## **HUMAN FACTORS EVALUATION OF THE SINCGARS ICOM RADIO**

Richard L. Palmer

U.S. Army Research Institute  
Fort Hood Field Unit

April 1987

Figure 1. Front panel of the SINGGARS first-generation Integrated COMSEC (ICOM) radio.

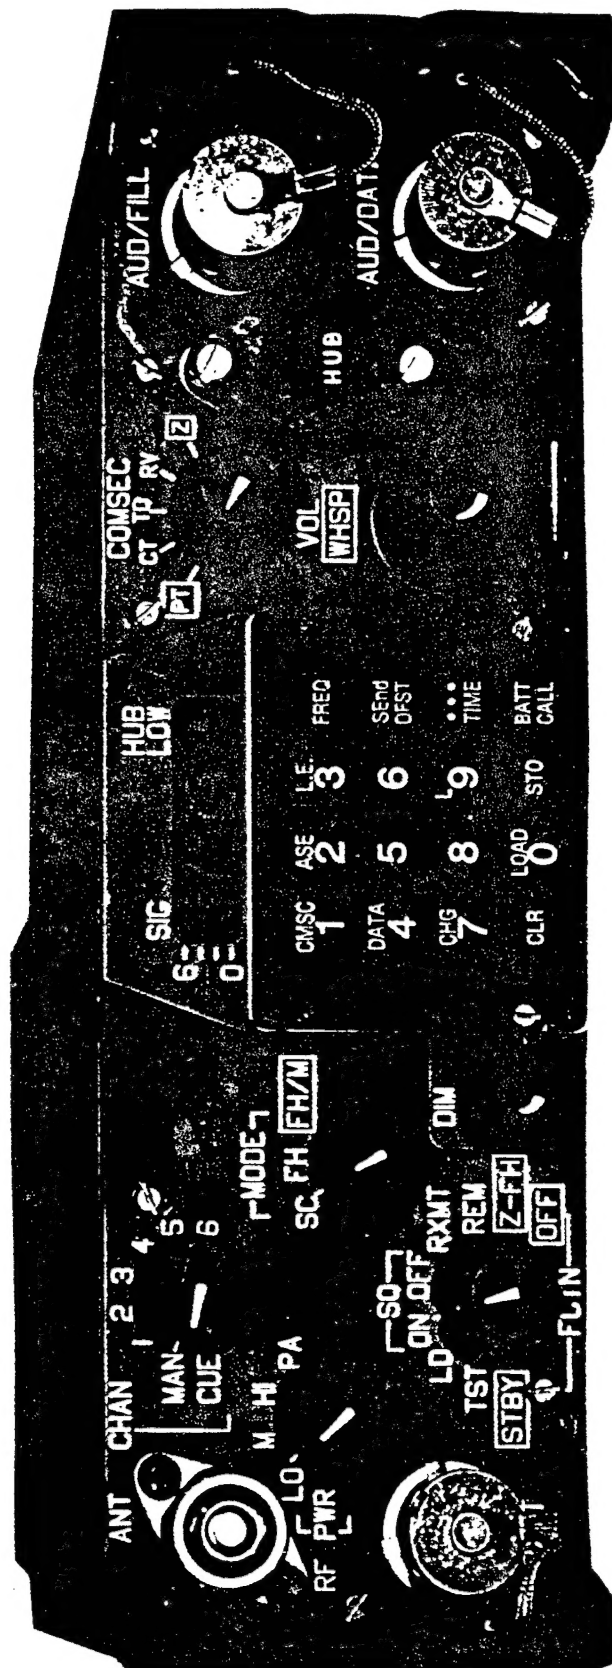
1.01 **OBSERVATION:** The RF PWR switch can be set midway (on the "high points") between normal settings. (Cf. Observation 1.02.)

**IMPACT:** A specific violation of MIL-STD-1472C (par. 5.4.2.1.1.4.c). Display anomalies result from keying the handset when the control switch is set between normal stops: When the control is set between "M" and "HI," the signal strength display indicator shows a 3 x 7 dot matrix (indicating "HI"); when the control is set between "M" and "LO," the indicator may show either a 3 x 1 ("LO") matrix (bottom line) or a 3 x 3 ("M") matrix (bottom three lines). (Cf. Observation 2.02.)

- 1.02 **OBSERVATION:** The CHAN switch can be positioned between normal settings at the high points of resistance. (Cf. Observation 1.01.)

**IMPACT:** A specific violation of MIL-STD-1472C (par. 5.4.2.1.1.4.c). On the radio examined, the display reacted as follows:

- 1.03 **OBSERVATION:** The arrangement of channels on the CHAN switch and the corresponding display indications in the single-channel mode are as follows:

**IMPACT:** The arrangement of channels on the CHAN switch does not have an intuitive correspondence to the display indications, which may be detrimental to ease of training and retention. (Cf. Observation 2.09.)

- 1.05 **OBSERVATION:** The visual parallax distortion associated with the rotary controls on the ICOM radio (as on the non-ICOM radio) is considerable, especially for the FCTN switch.

**IMPACT:** It is difficult for the operator to determine visually the setting of the control if it is viewed from an angle. The problem would be exacerbated in low light. For example, the FCTN switch (which is very crowded with settings and labels) appears to be set at "REM" if the operator views the switch from as little as 15 degrees above and 15 degrees to the left of center when in fact it is set at "RXMT." Accurate readings are guaranteed only if the operator views the control panel from a fairly straight-on position.

- 1.06 **OBSERVATION:** The front panel controls (including the keyboard) are not illuminated for use in low-light or no-light situations. Operators of the non-ICOM radio have viewed this as a significant problem.

- 1.07 **OBSERVATION:** The volume control knob can be accidentally moved because of its lack of sufficient resistance to turning.

**IMPACT:** Accidental movement to a minimum or near minimum setting may render reception inaudible. Inadvertent maximum settings could breach noise discipline in tactical situations or hurt the operator's ears. Because the radio may not be receiving signals much of the time, the effect of accidental movement of the volume control may not be immediately apparent. This problem is aggravated by the lack of meaningful level markings (cf. Observation 3.19).

- 3.01 **OBSERVATION:** The label "RF PWR" on the power switch is unnecessarily specific and abbreviated.

**COMMENTS/POSSIBLE IMPROVEMENTS:** Improve the design of the switch to eliminate its ability to stop midway between intended settings. (The problem is not considered serious from a human factors perspective)

**COMMENTS/POSSIBLE IMPROVEMENTS:** The non-ICOM radio probably had a more satisfactory arrangement of channels on the channel selector (MAN, 1, 2, 3, 4, 5, 6, CUE). Apparently the arrangement was changed to comply with the general rule of thumb prescribing that the arrangement of controls should correspond to frequency of use. Regardless, the current "solution" appears to be worse than the original "problem." Two alternative suggestions for improvement are offered:

**COMMENTS/POSSIBLE IMPROVEMENTS:** Control knobs should be designed to minimize visual parallax problems. Some modification of the knobs on the control panel of the ICOM could help (ref. MIL-STD-1472C, par. 5.4.2.1.1.3 & Figure 4), as might a reduction in the number of positions on the FCTN switch (cf. Observation 3.03, Comment).

**COMMENTS/POSSIBLE IMPROVEMENTS:** Improvement appears to have been made in the readability of the controls with night-vision devices. Perhaps that is the most that can be expected under conflicting trade-off situations that constrain solutions to this problem. Ideally, the radio would have some sort of available panel lighting that would constitute a minimal security threat and require little in the way of battery power. (In vehicles the lighting would utilize vehicle power.)

**COMMENTS/POSSIBLE IMPROVEMENTS:** Increase the control's resistance to movement.

**COMMENTS/POSSIBLE IMPROVEMENTS:** Simplify the label by changing it to "POWER."
